# UNITED STATES PATENT AND TRADEMARK OFFICE

10/540,143

<b>Office Action Summary</b>	<b>Application No.</b> 10/540,143	<b>Applicant(s)</b> KATSUMATA ET AL.	
	<b>Examiner</b> William H. Mayo III	<b>Art Unit</b> 2831

## **DETAILED ACTION**

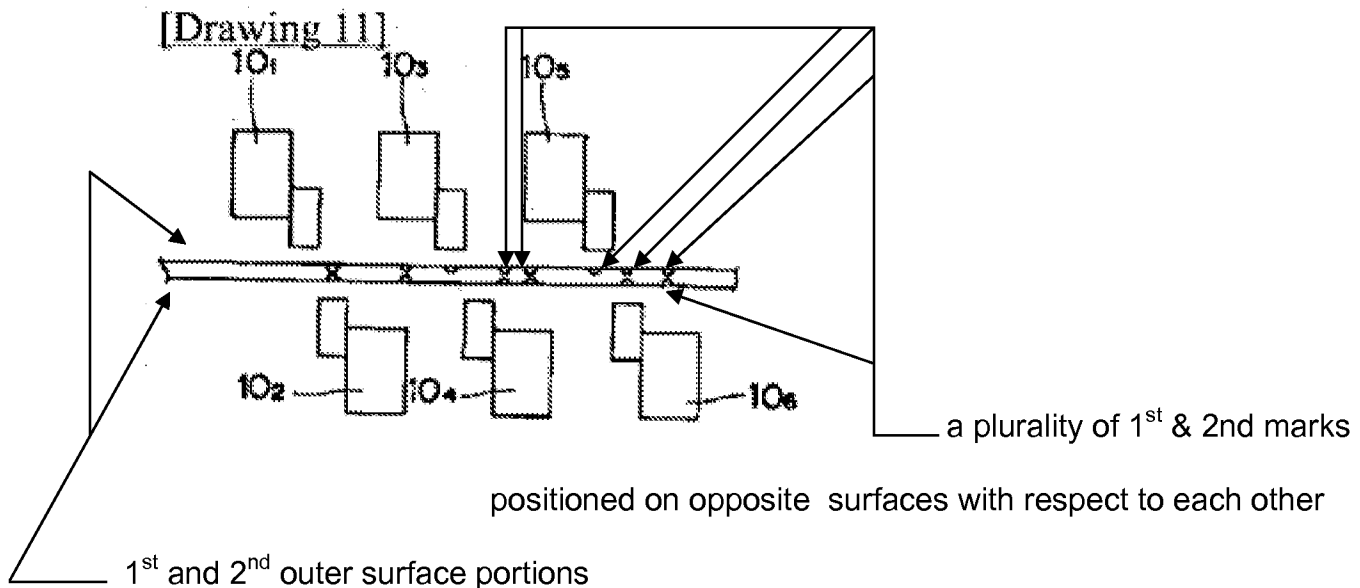
Masuda clearly illustrates in Figure 11 a plurality of nozzles (10<sub>1-6</sub>) for providing a plurality of markings (not numbered in Figure 11, however as shown in Figure 12) having three distinct colors, which are alternatively repeated along the length of the cable (see paragraph 9 provided for reference above). Specifically, Masuda illustrates

While the marks are not denoted, Masuda clearly states in the description (see paragraph 12) that the markings illustrated in Figure 11 are the markings denoted as Ma, Mb, & Mc in Figure 12. Figure 11 clearly shows that the markings are inked along the length of the cable on a first and second outer surface portion (i.e. top and bottom surface portions). Figure 12 clearly shows a plurality of three different markings that are utilized with the ink nozzles ((10<sub>1-6</sub>) of Figure 11 (see paragraph 9 above).

Masuda also refers to the electrical wire (6 as denoted in Figures 9a-b) when referring to the wire in Figures 11 & 12 (see paragraph 9 above).

Therefore, Masuda clearly teaches the first and second outer surfaces (outer surfaces of the left and right ends) may be provided with a plurality of first and second marks (Ma & Mb & Mc) that are alternately positioned (Fig 11 & 12) in a longitudinal direction (Fig 12), wherein the first mark (Ma) and the second mark (Mc) are positioned at an end of the cable (Figs 11 & 12, Page 2 of Detailed Description, paragraph 9). In light of the above stated comments, the examiner respectfully submits that the 35 USC 103(a) rejection is proper and just.
